GARAGE / BEAM & SUPPORT COORDINATION DRAFT

Current support positions drive draft member axes. Geometry only; bearing details unresolved.
OB1 is listed separately as outbuilding context. E-M is option B only. Roof/loft outlines are plan limits.

T-S / PARAMETRIC TRUSS STUDY

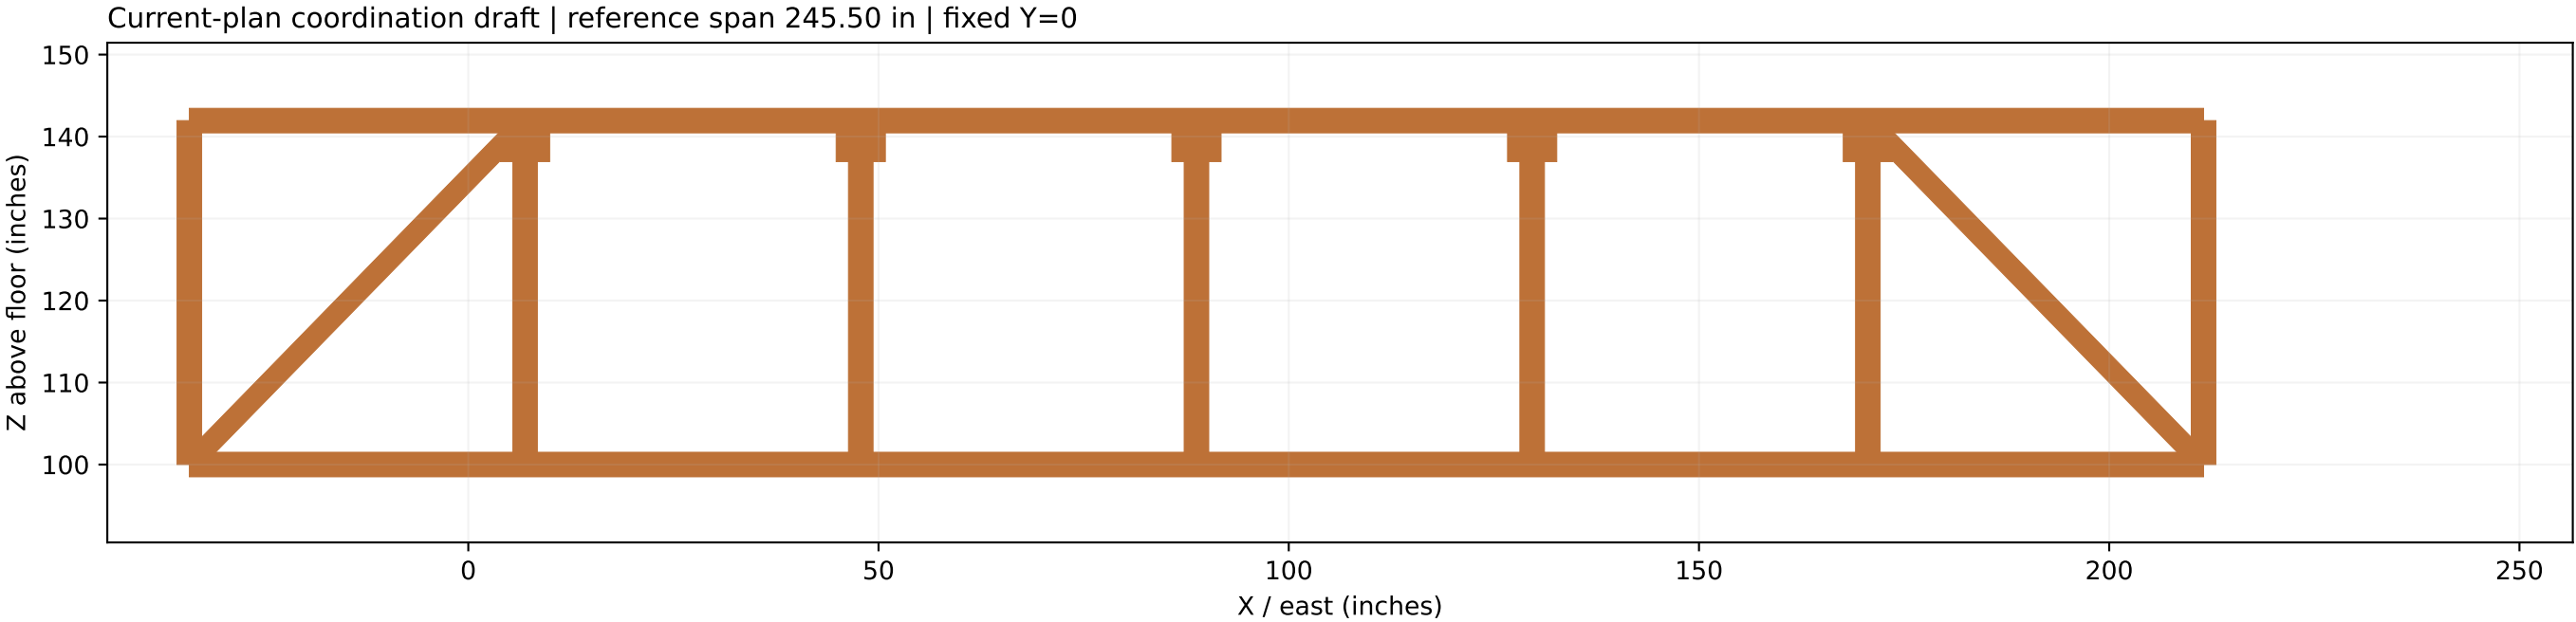
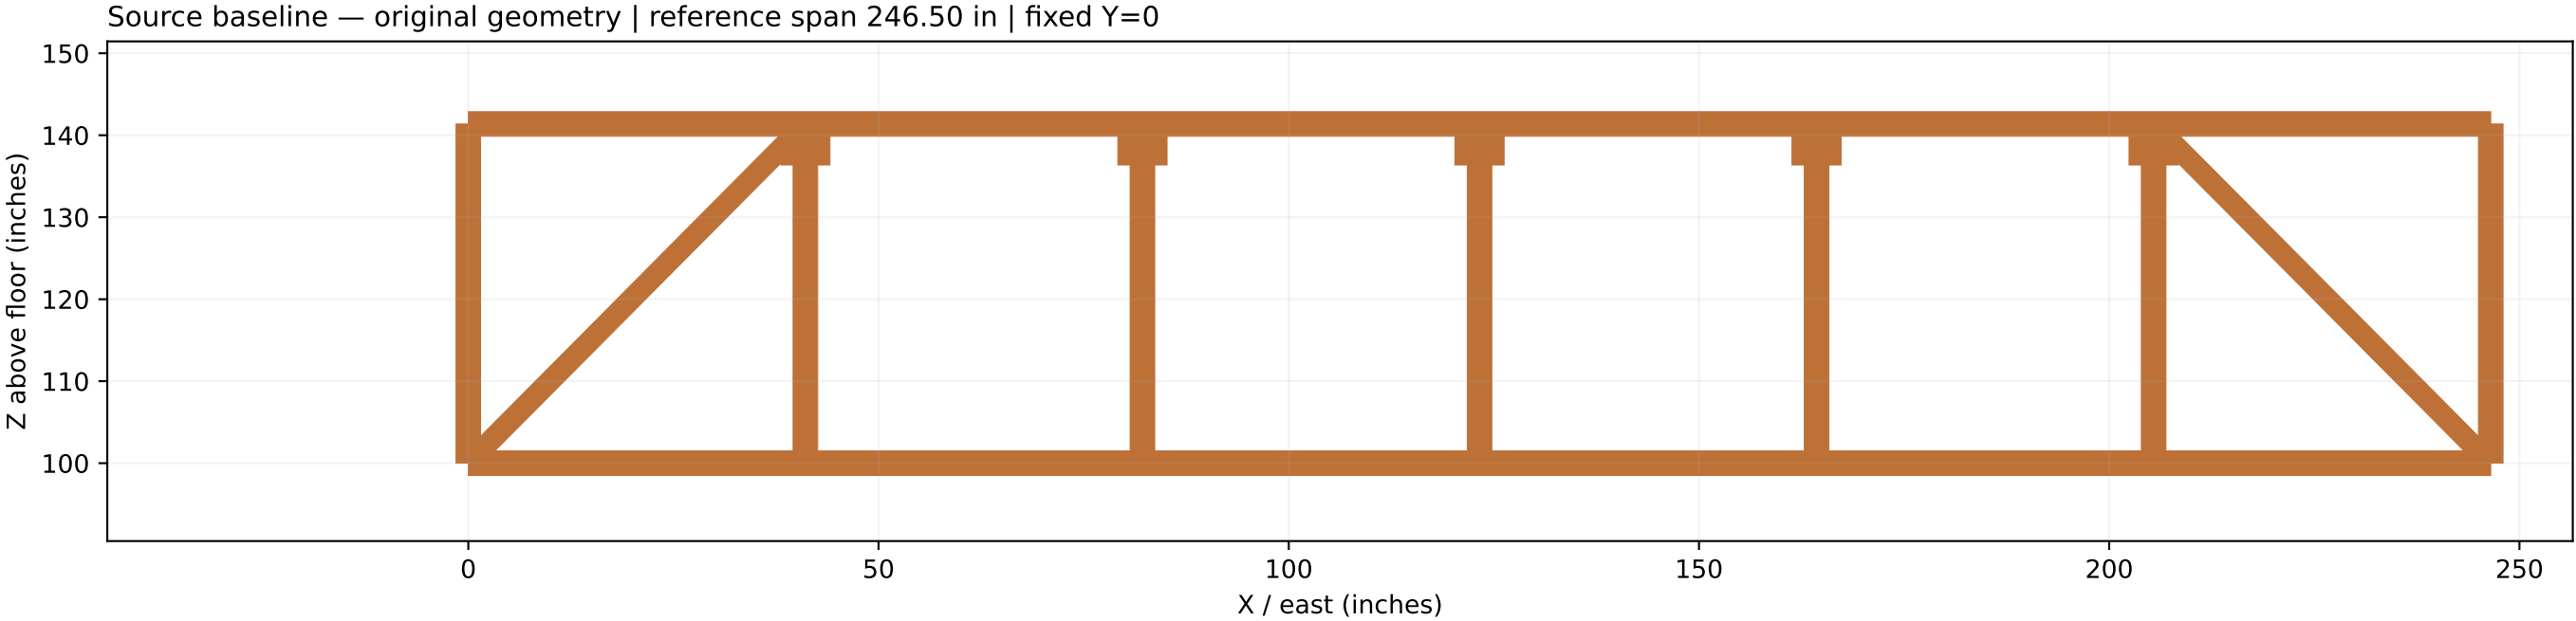
9. Ground-floor N1/N2 bay is 192 inches center spacing / 188 inches between 4-inch symbols, separate from the T-N loft door.
10. T-S at Y0 is 2 inches north of S3 at Y=-2; south beam Y=-64 is 2 inches north of the south columns.

T1 / PARAMETRIC TRUSS STUDY

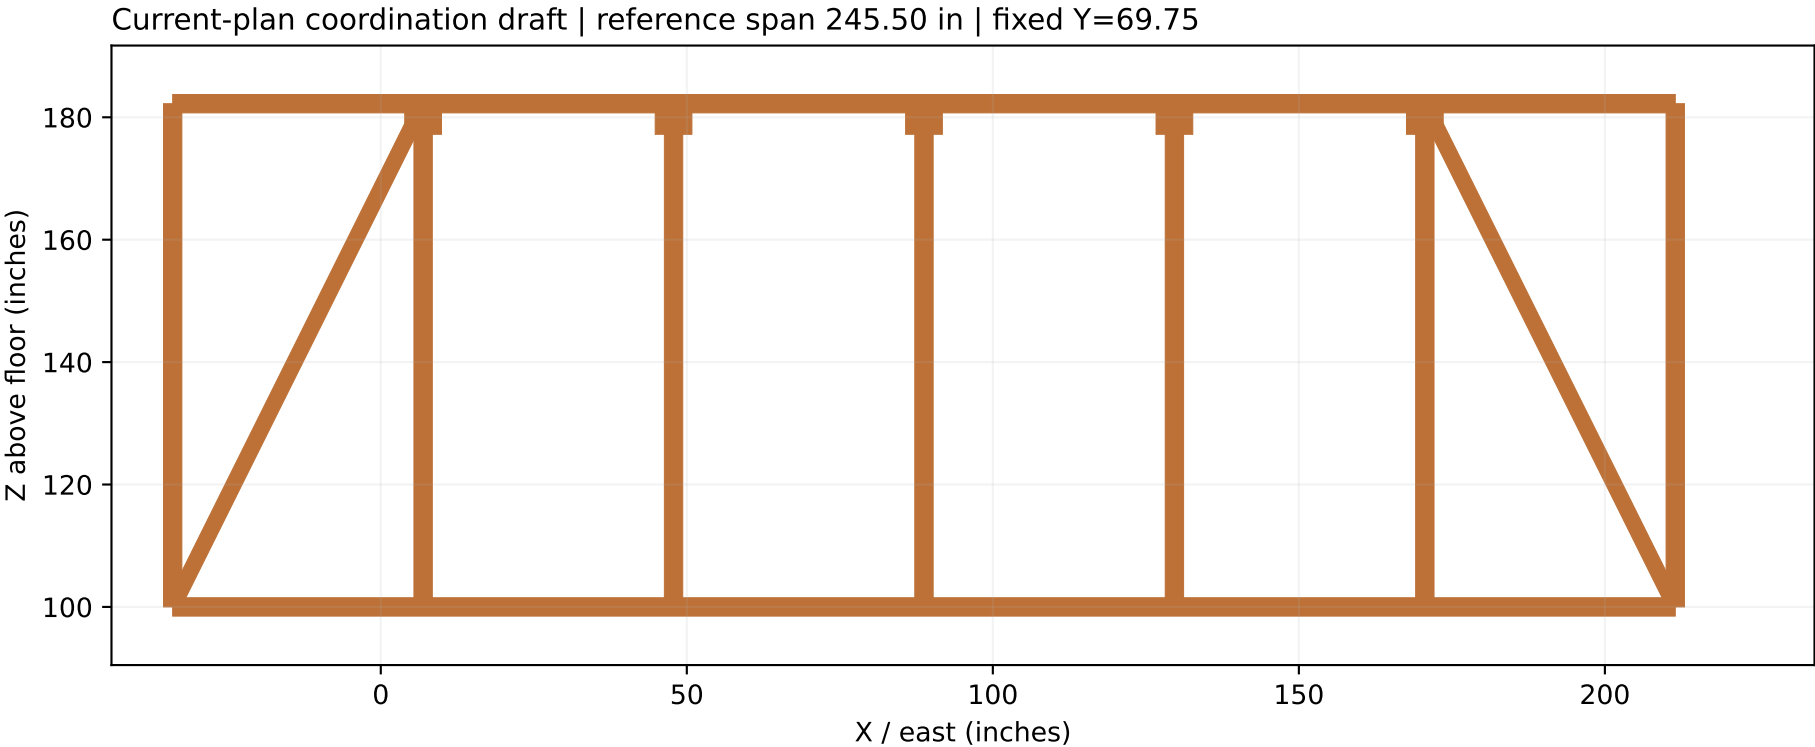
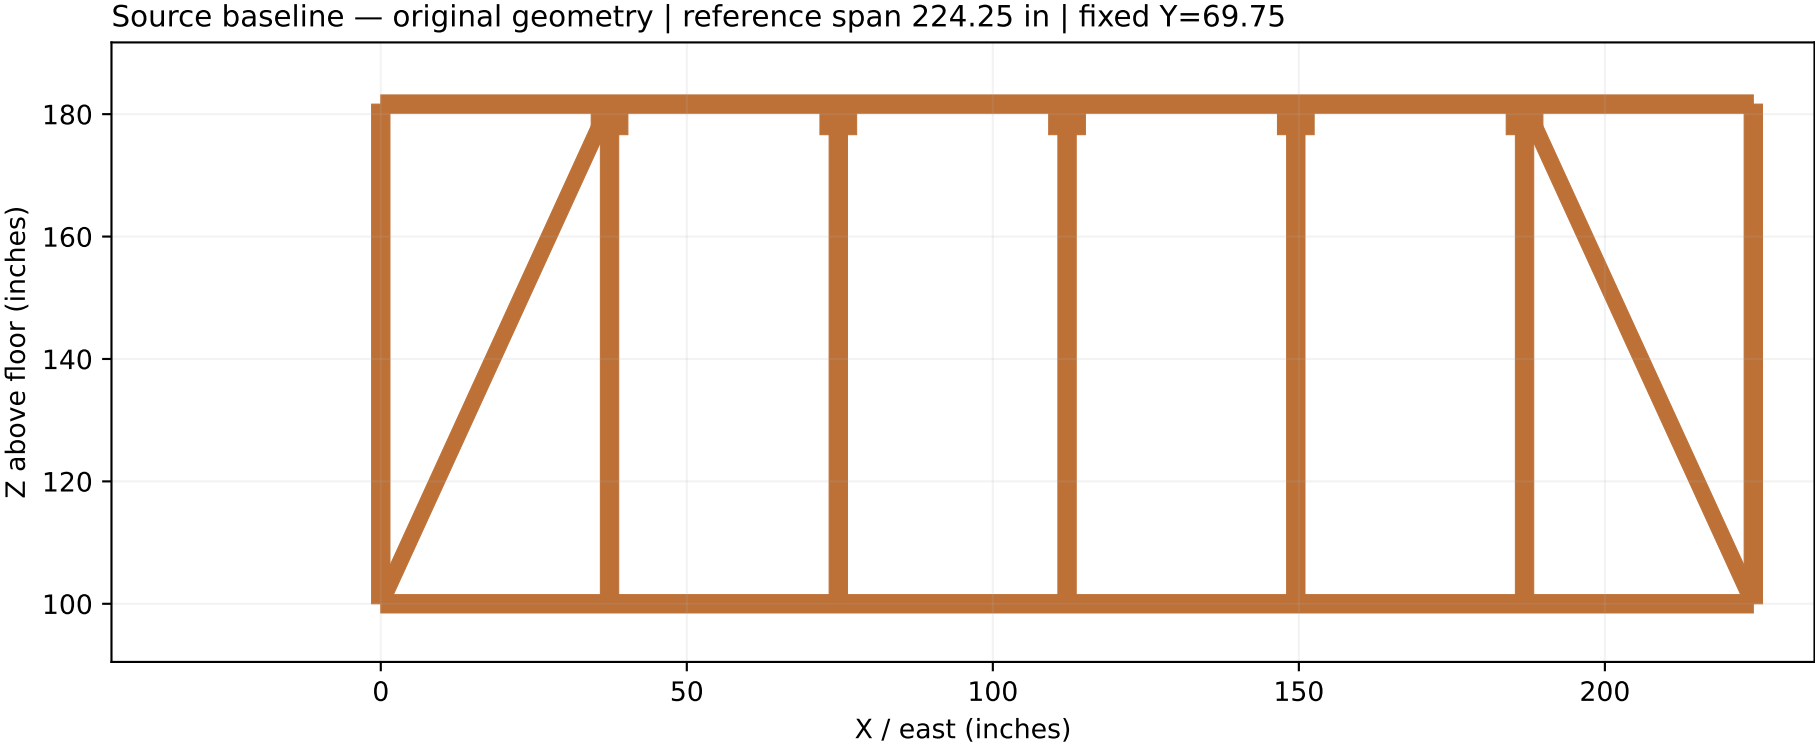
1. Draft roof retains 30 degrees and old heights, but starts at current T-SO Y=-64. Current roof design is not finalized.
2. User correction: T-W is on the far-west column row X=-34. Cross-members now extend to that row; O2/O3 are subsegments of T1/B2, not separate beams.

T-W / PARAMETRIC TRUSS STUDY

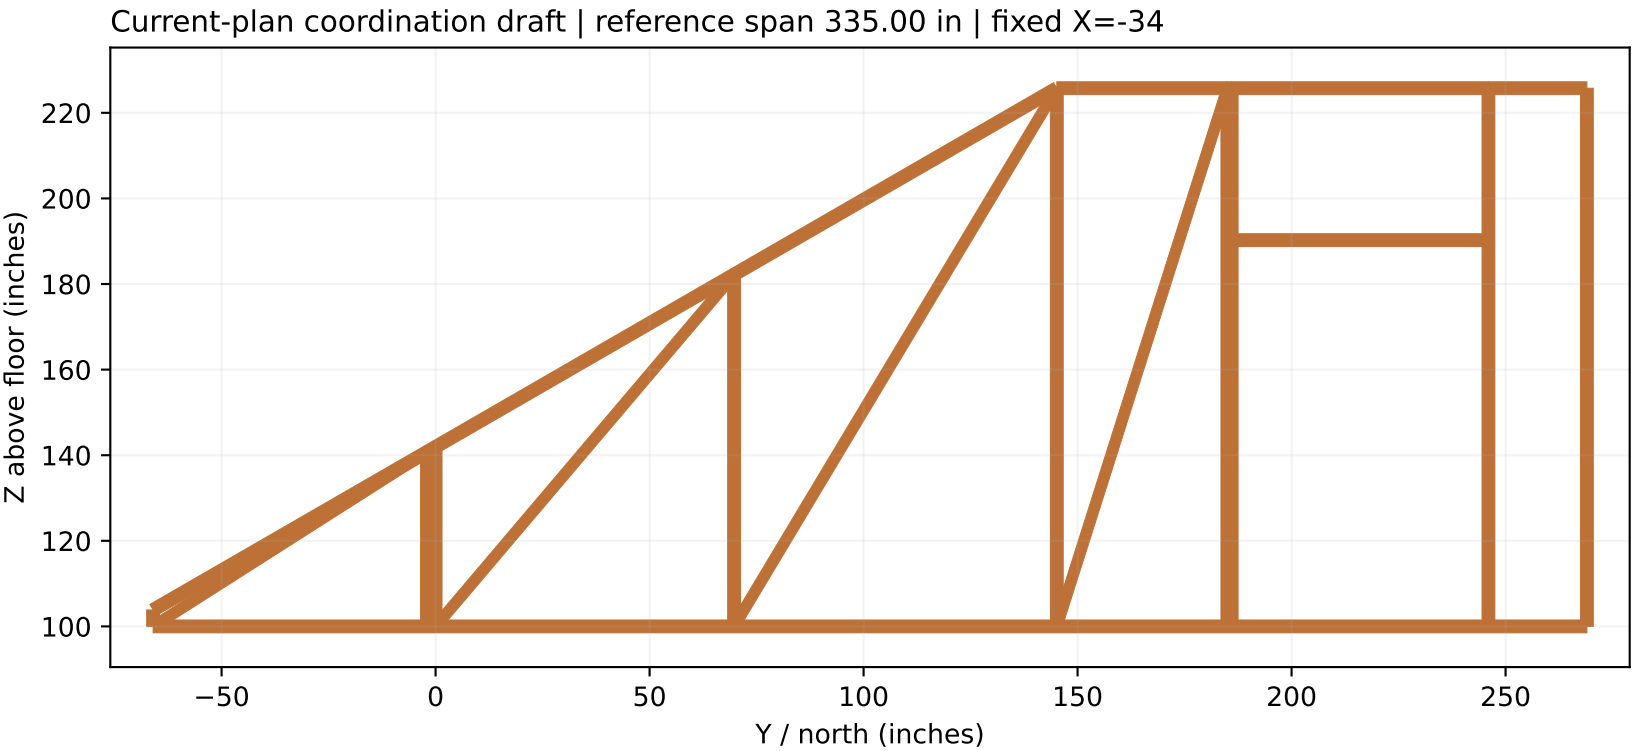
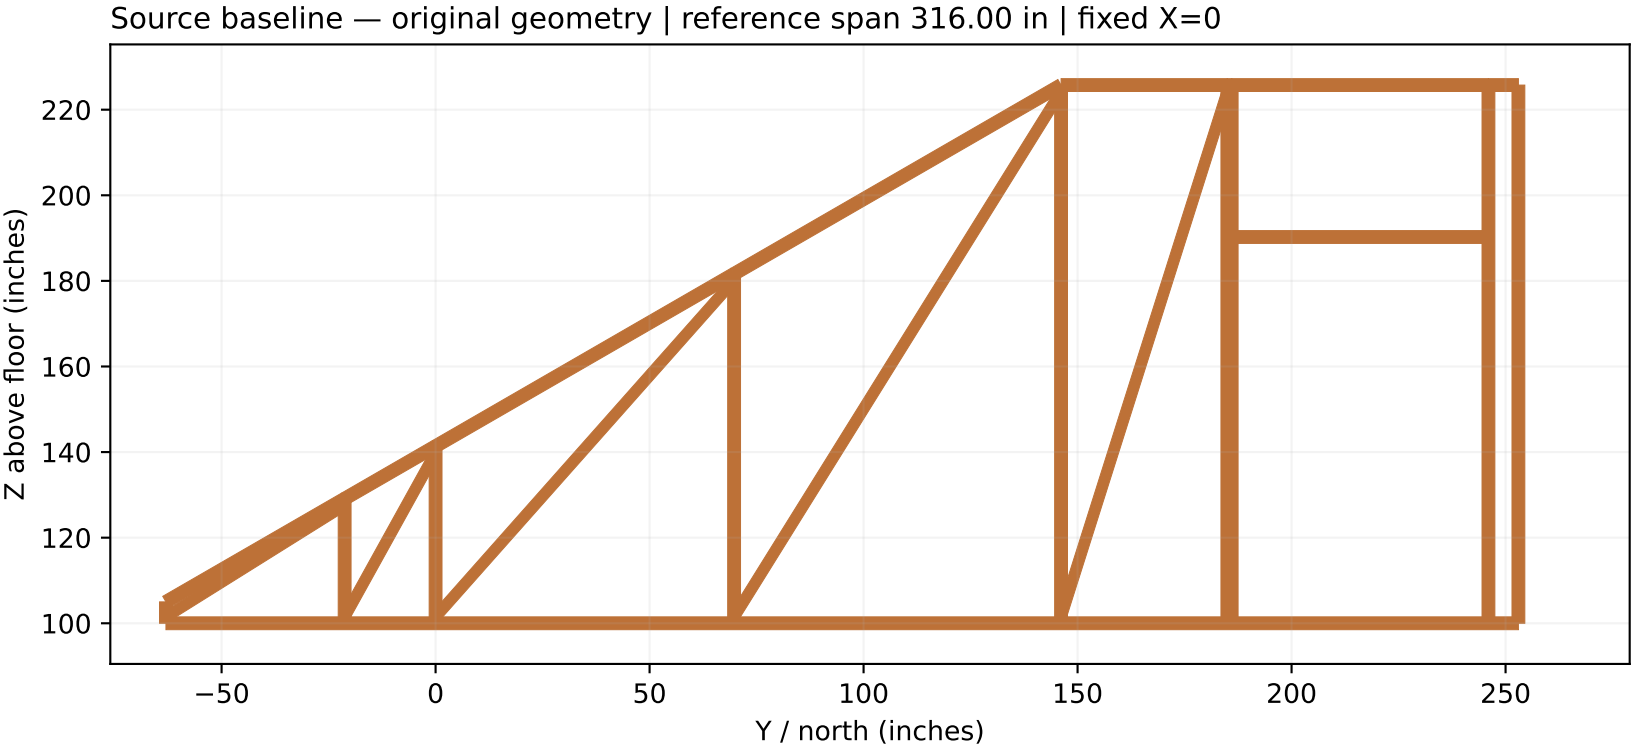
5. E-OB sits at Z98.5 with a provisional 3-inch display envelope matching truss chords; section sizing is unresolved. OB1 elevation remains unknown.
6. T-W source uprights at Y185 and Y186 are only 1 inch apart with 3-inch envelopes: overlap retained for review.

7. T-N loft-door jamb axes X81.5/113.5 give 29 inches between 3-inch faces; source 32 inches is axis spacing.
8. T-W source door header gives 81.5 inches from loft floor to underside; source opening height needs coordination.

T-E / PARAMETRIC TRUSS STUDY

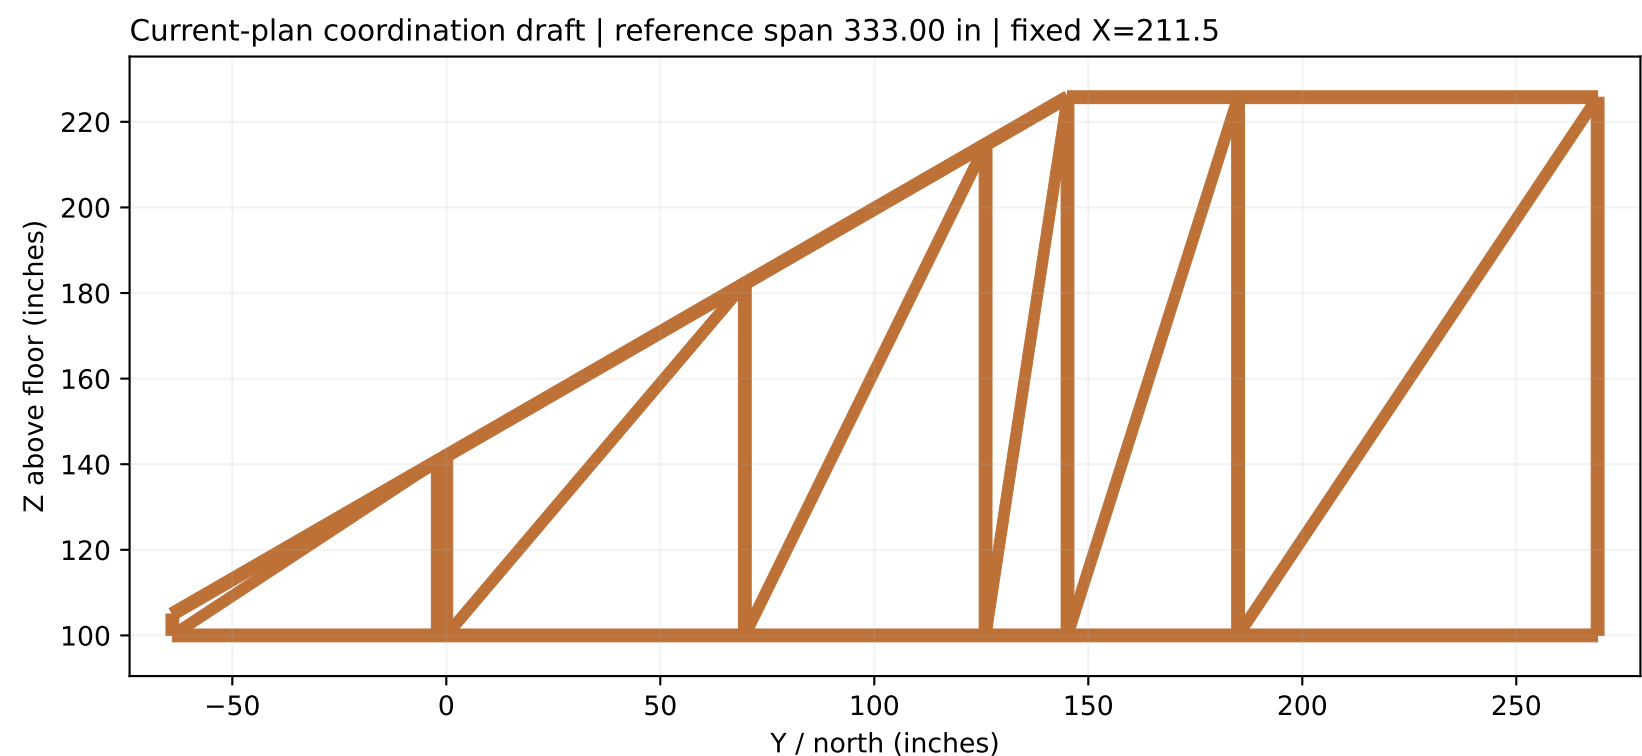
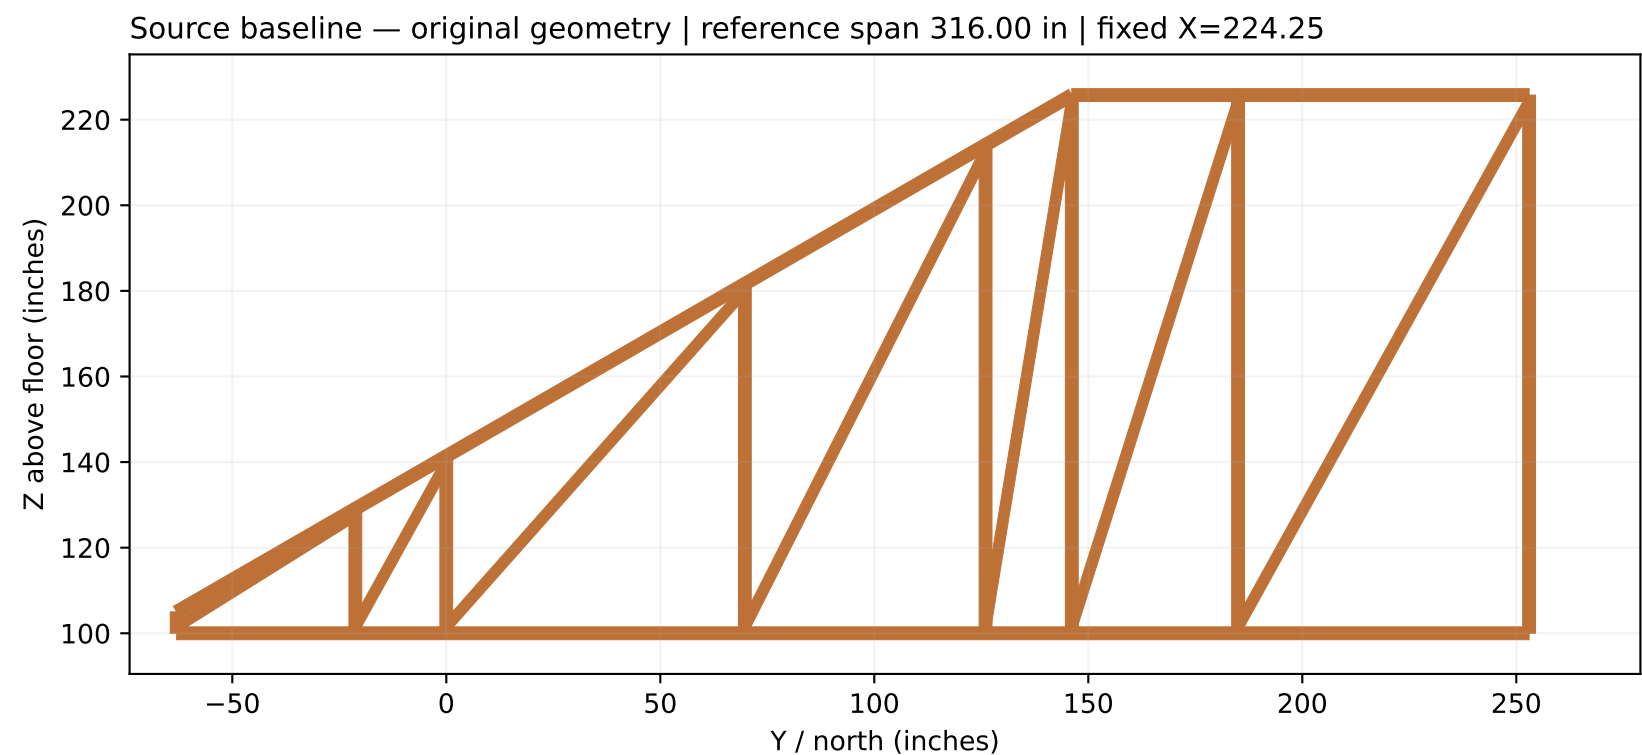
11. E-S connects to S3; E-M/E-N connect to T-E at Z98.5 as unsized references. E-M retains option B and its 1-inch offset from E-OB.
12. Truss 3-inch section envelopes have not been reconciled with the plan outside-face limit at X213.5.
